Proposal #26: 1130-65-76, WISC 2025323
Appleton – De Pere
Ballard Rd (CTH E) Intchg
IH 41
Outagamie County

This is Addendum No 01, which provides for the following:

ADDENDUM NO. 01

1130-65-76

Addendum No. 01
ID 1130-65-76
Added Sheet 39A
January 30, 2025

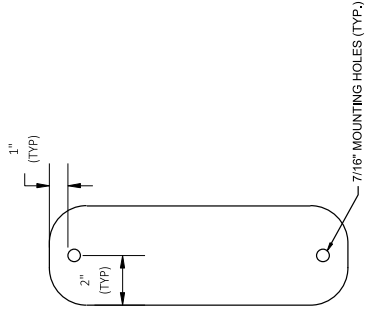
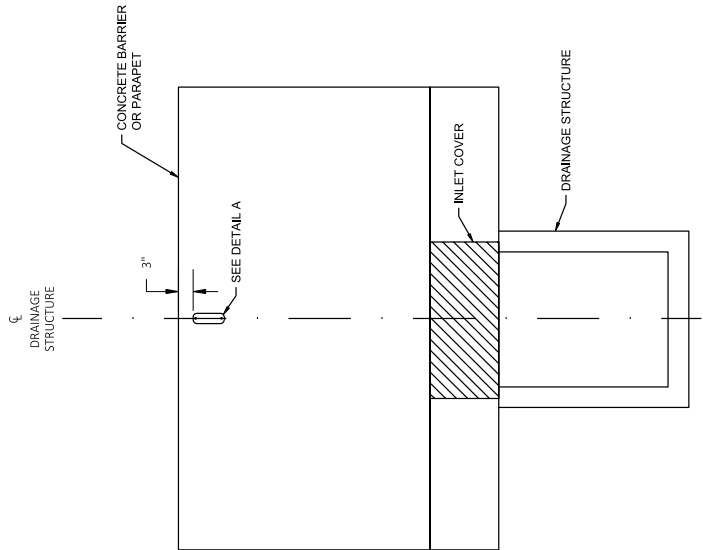
Added Plan Sheets	
Plan Sheet	Plan Sheet Title (brief description of why sheet was added)
39A	Inlet Marker Detail
197A-197C	Lighting Details
444A	MQ Sheet – Decorative Silhouette
449A	MQ Sheet – Inlet Marker
518A	Standard Sign
894A	Silhouette Detail

This special provision describes furnishing and installing a Type II W5-53S sign to mark inlet locations adjacent to barrier wall or parapets as shown in the plans, in accordance with standard spec 637, and as hereinafter provided.

- NOTES:
- 1. STANDARD SIGN W5-53S, SIZE 2M (SIGN PLATE W5-53S, LOW INLET MARKER)
 - 2. 3/8" X 1" STAINLESS STEEL ANCHOR WITH NYLON AND STAINLESS STEEL WASHERS.
 - 3. ANCHORS SHALL HAVE HEXAGONAL HEADS.
 - 4. SEE SIGN PLATE A4-8 FOR ADDITIONAL INFORMATION REGARDING WASHERS.

Addendum No. 01
ID 1130-65-76
Revised Sheet 52
January 30, 2025

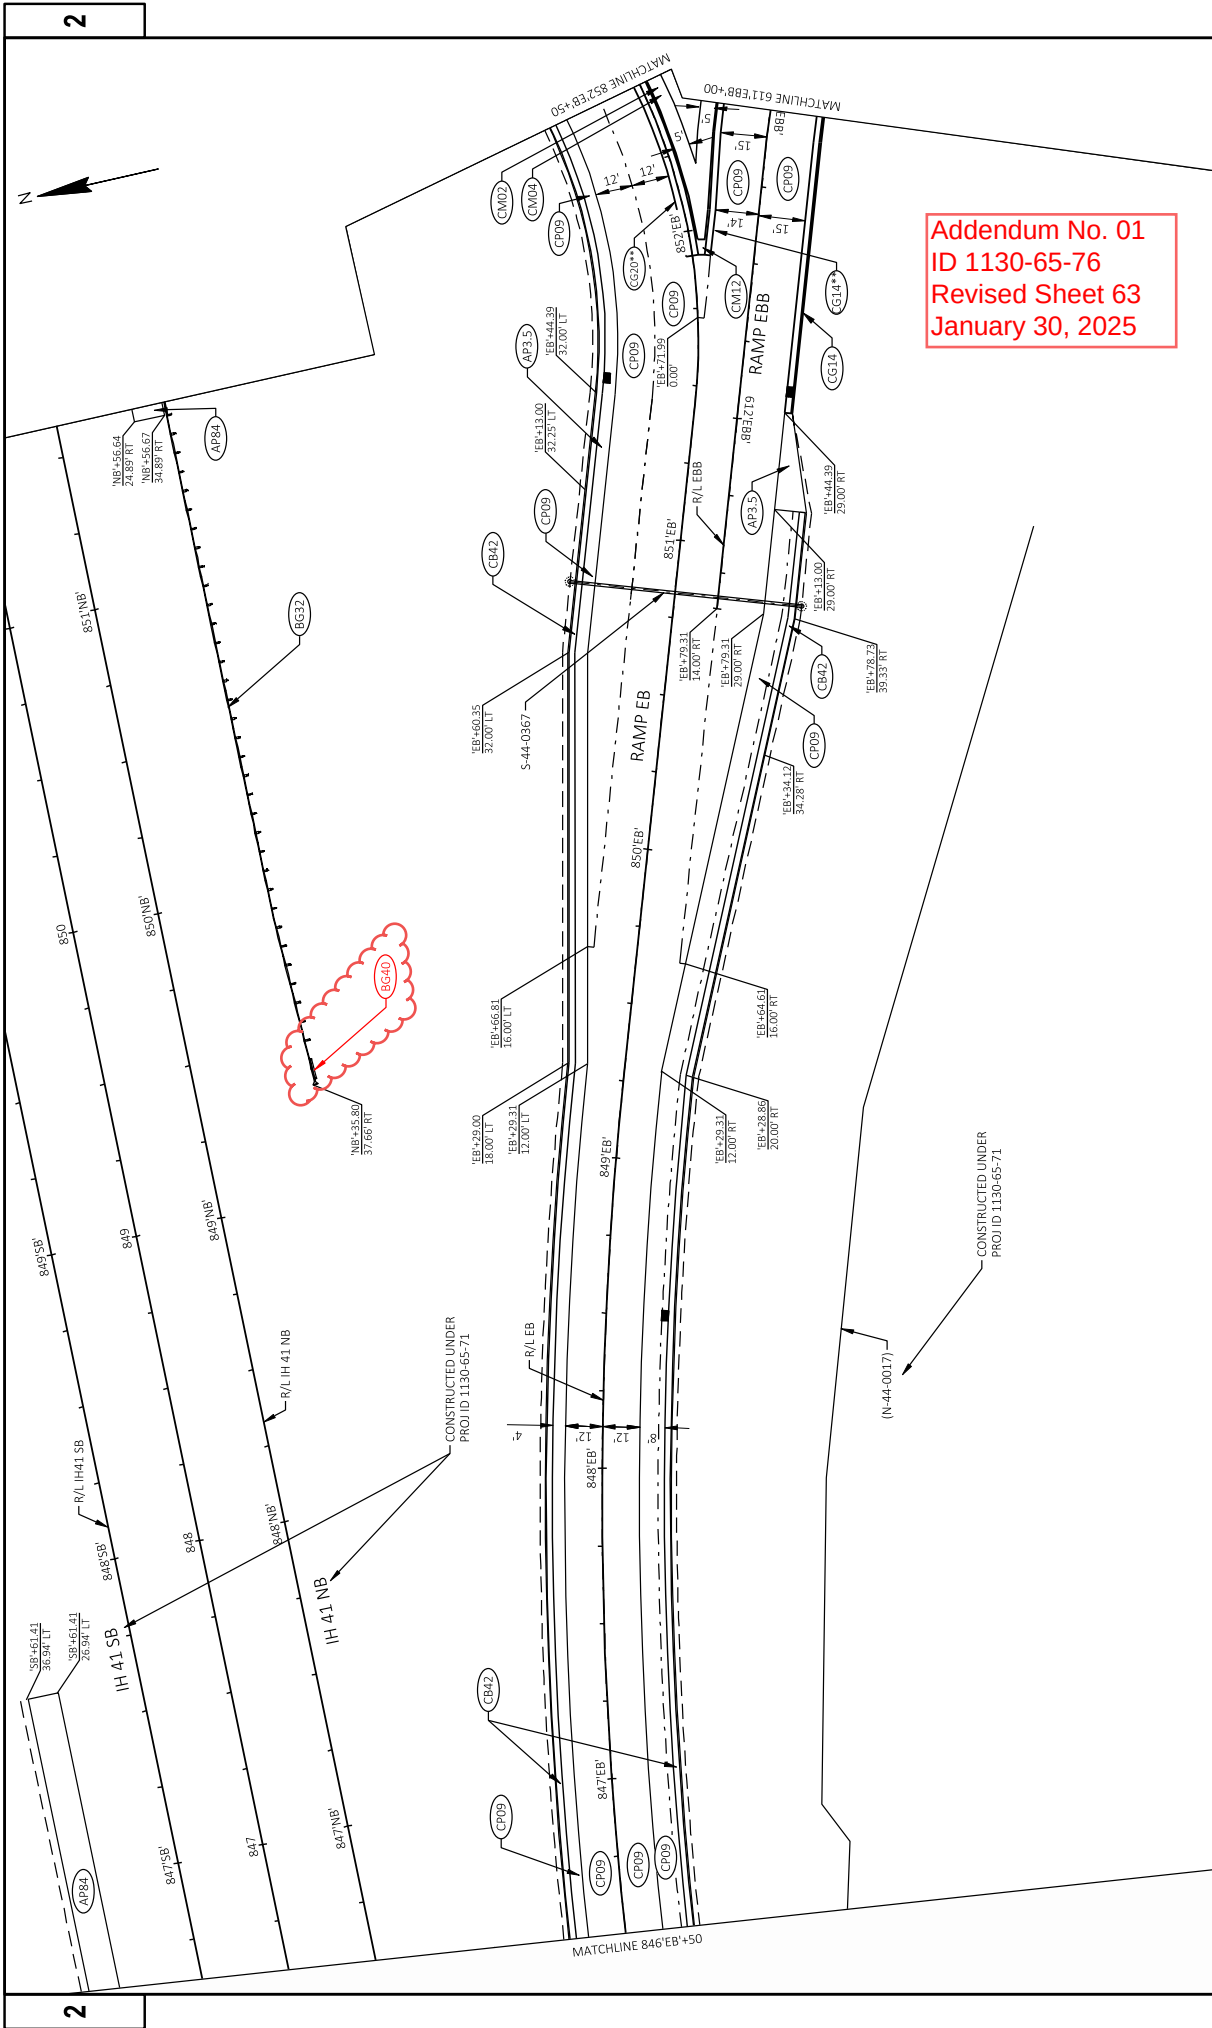
Revised Plan Sheets	
Plan Sheet	Plan Sheet Title (brief description of changes to sheet)
3	General notes – Revised HMA type
52	Plan Detail Legend – removed temporary EAT
63	Plan Detail – Revised callout of EAT
68	Plan Detail – Revised callout of EAT
435	MQ Sheet – Revised HMA quantity
440	MQ Sheet – Revised EAT quantity

924

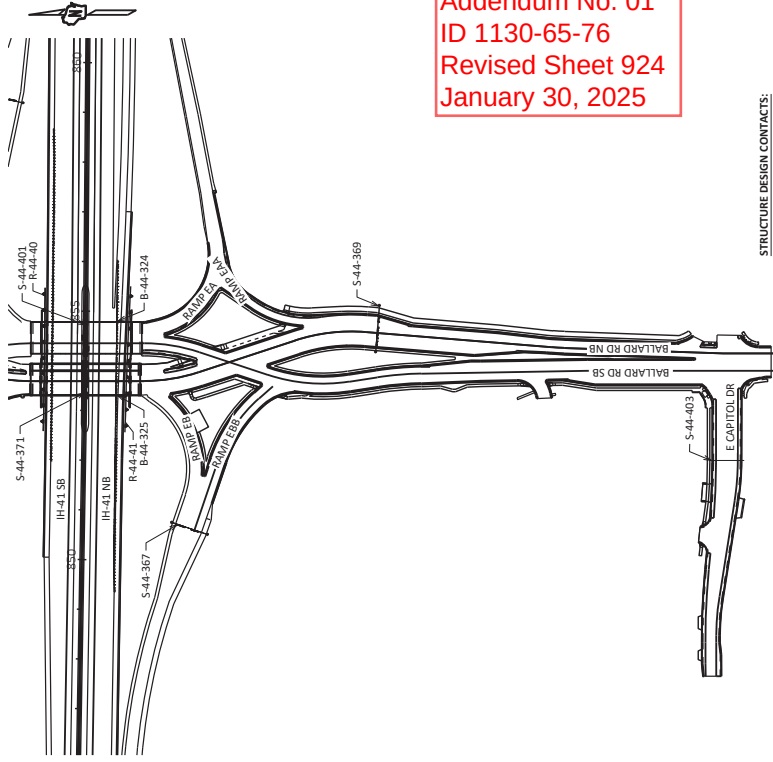
NO.	DATE	REVISION	BY
1	1/28/25	DRILLED SHAFT FOUNDATION REVISED TO 36" DIA.	TMH

Revised Bid Item Quantities					
Bid Item	Item Description	Unit	Proposal Total Prior to Addendum	Proposal Quantity Change (-)	Proposal Total After Addendum
460.5224	HMA Pavement 4 LT 58-28 S	TON	1061	83	1144
614.2610	MGS Guardrail Terminal EAT	EACH	1	2	3
531.2036	Drilling Shaft 36-Inch	LF	10	26	36
